August 7, 2023

**RE: Boba Tea  
10611 Unser Blvd. NW  
Grading & Drainage Plan  
Engineer's Stamp Date: 07/19/23  
Hydrology File: A11D017D**

**GRADING & DRAINAGE PLAN**

**CG-101**

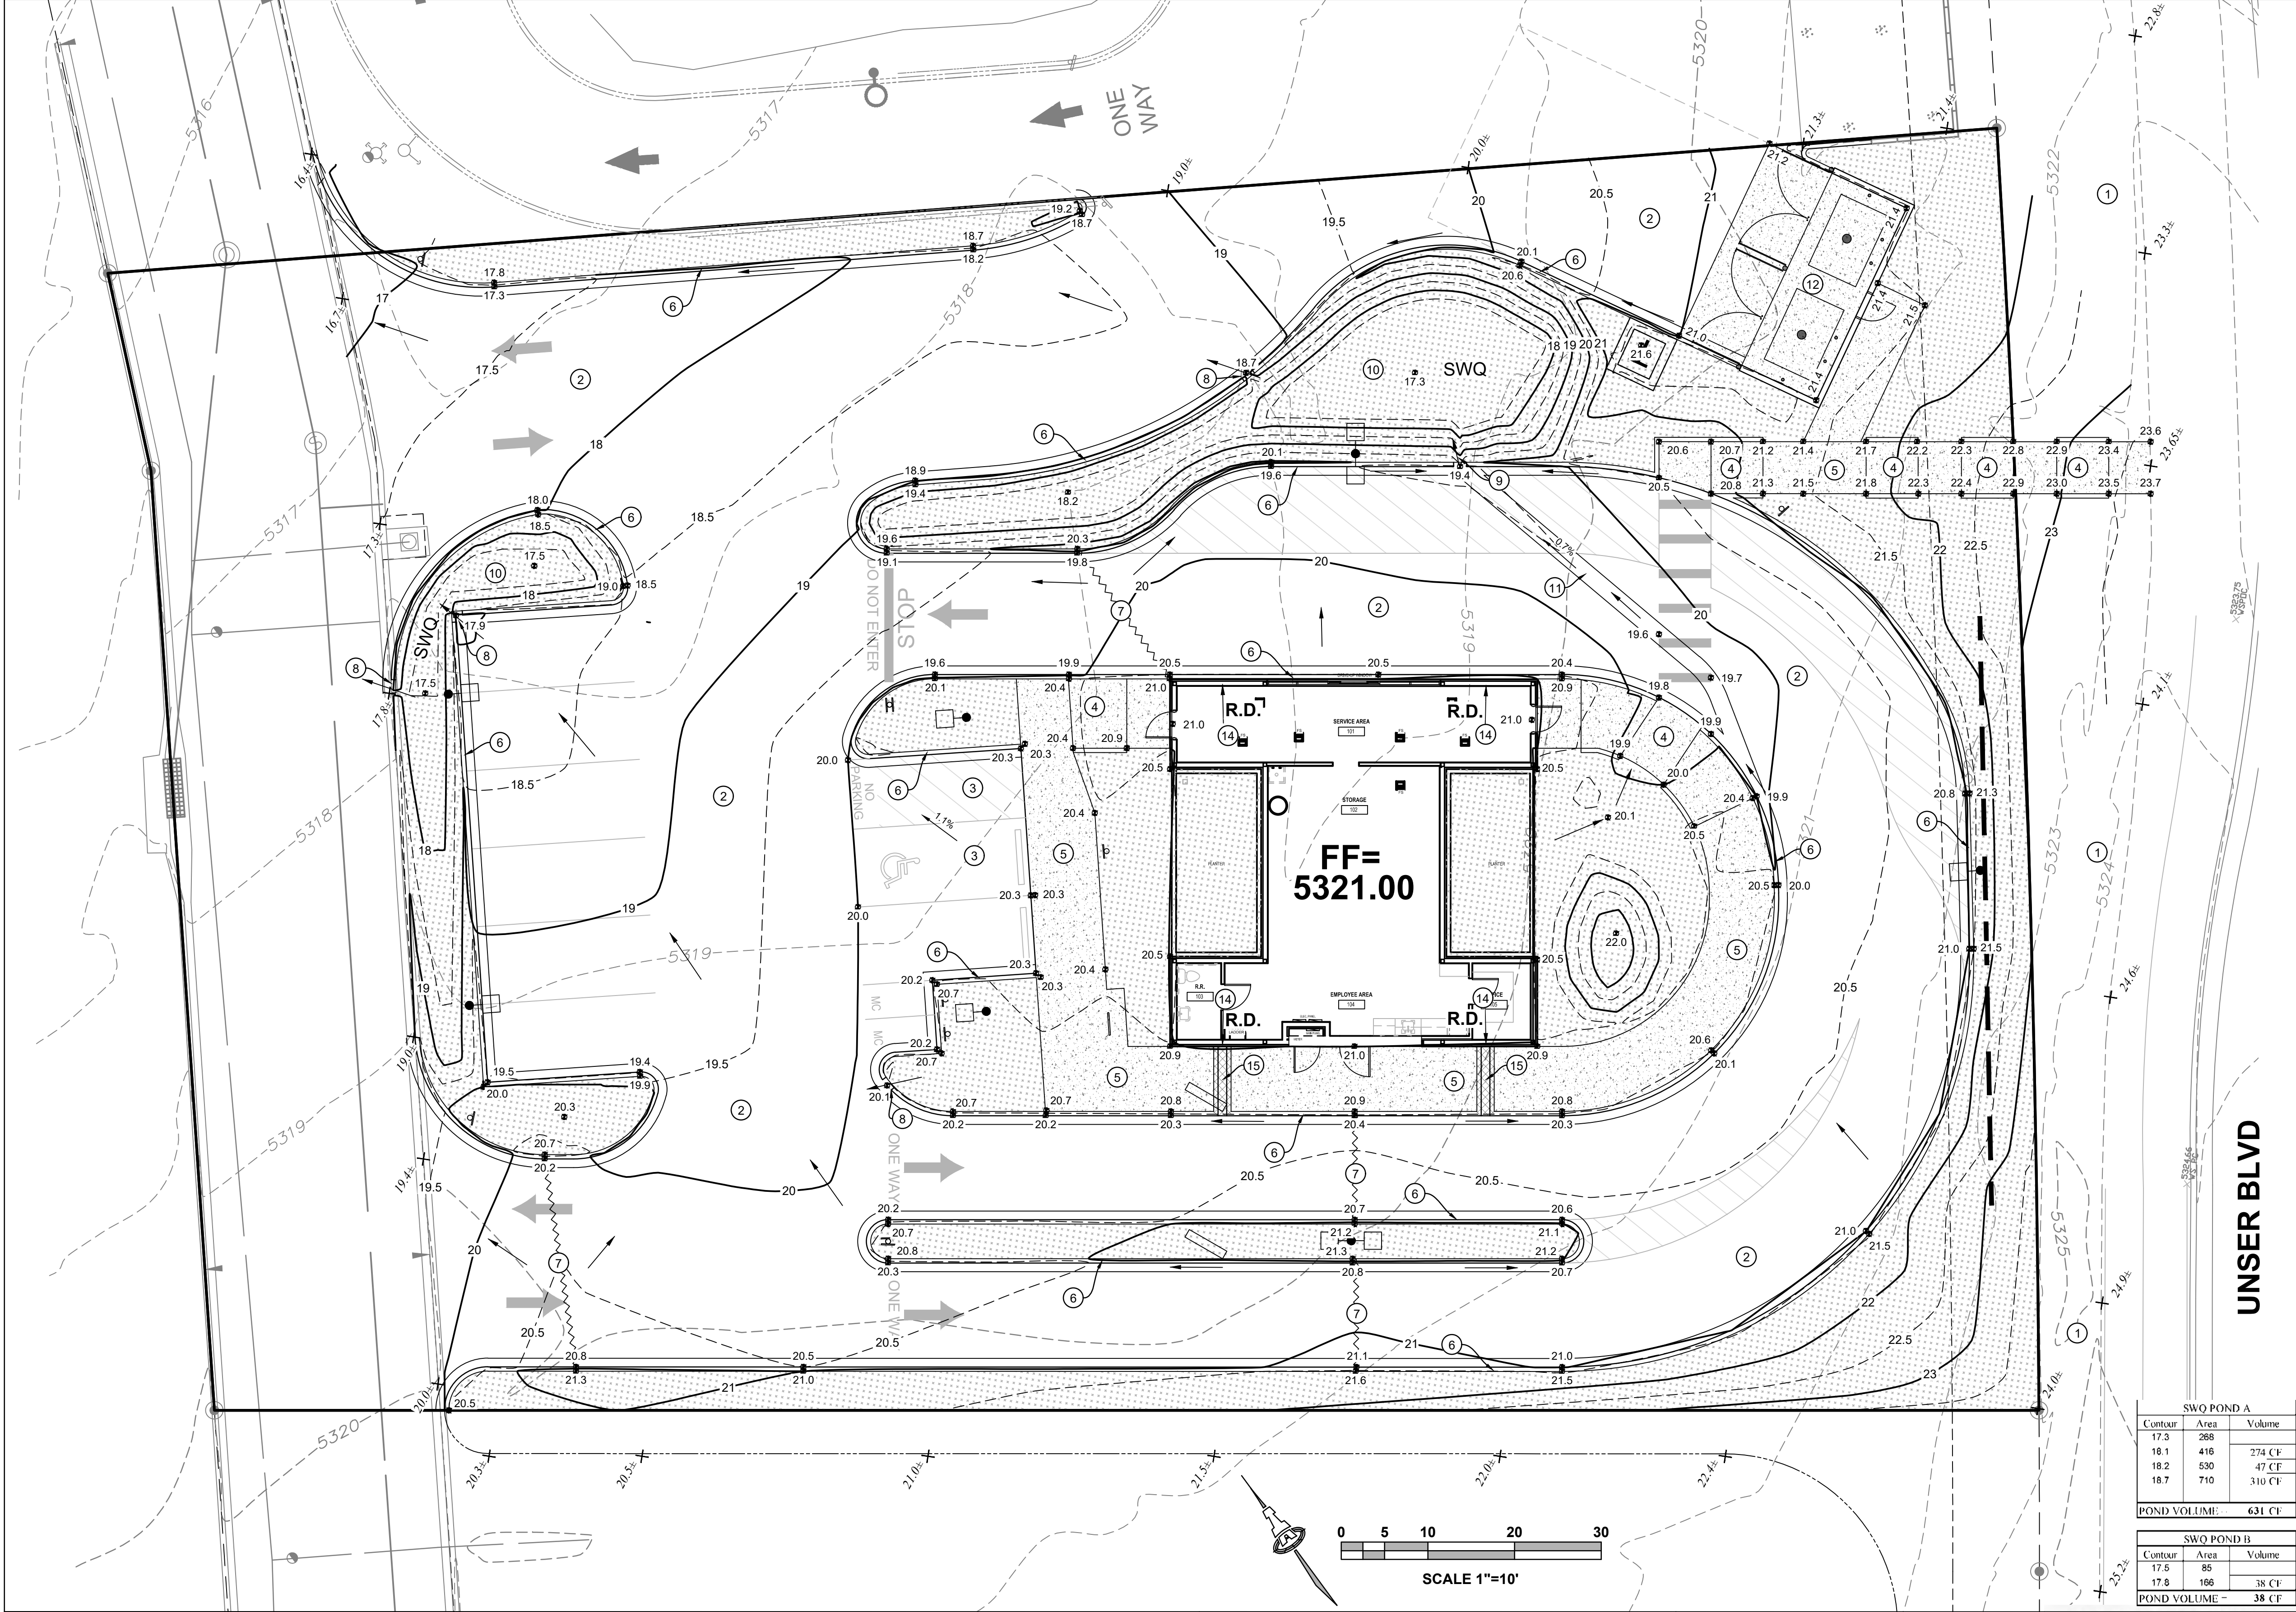
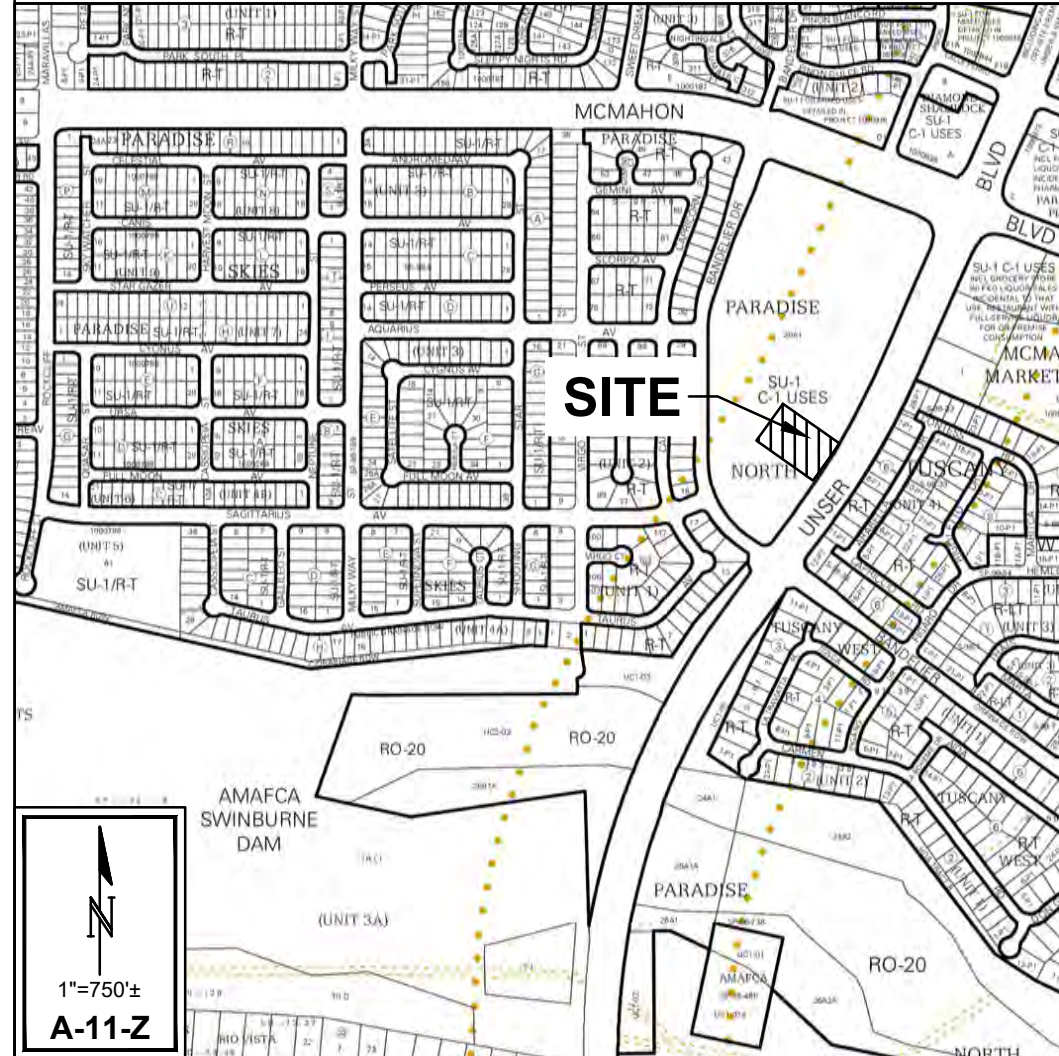
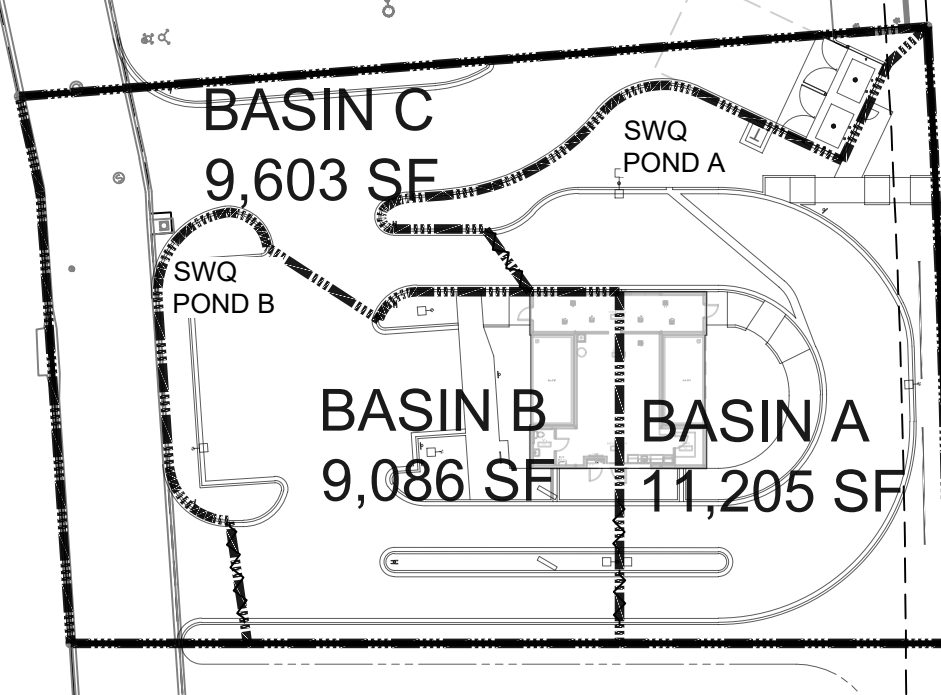
Based upon the information provided in your submittal received 07/24/2023, the Grading & Drainage Plan is approved for Building Permit and Grading Permit. Please attach a copy of this approved plan in the construction sets for Building Permit processing along with a copy of this letter.

1. Engineer's Certification, per the DPM Part 6-14 (F): *Engineer's Certification Checklist For Non-Subdivision* is required.
2. Please provide the executed paper Drainage Covenant (latest revision) printed on one-side only with Exhibit A and a check for **\$25.00** made out to "**Bernalillo County**" for the underground stormwater quality pond per Article 6-15(C) of the DPM to Hydrology for review at Plaza de Sol.
3. Please pay the Payment-in-Lieu of **\$ 1,008.00** by emailing the attached approved Waiver Application from Stormwater Quality Volume Management On-site to [PLNDRS@cabq.gov](mailto:PLNDRS@cabq.gov). Once this is received, a receipt will then be produced and email back. Follow the instructions on the bottom of the form and pay it at the Treasury in Plaza de Sol. Once paid, please provide me proof of payment.

☒ Waiver is approved. The amount of payment-in-lieu from above must be paid prior to Certificate of Occupancy.
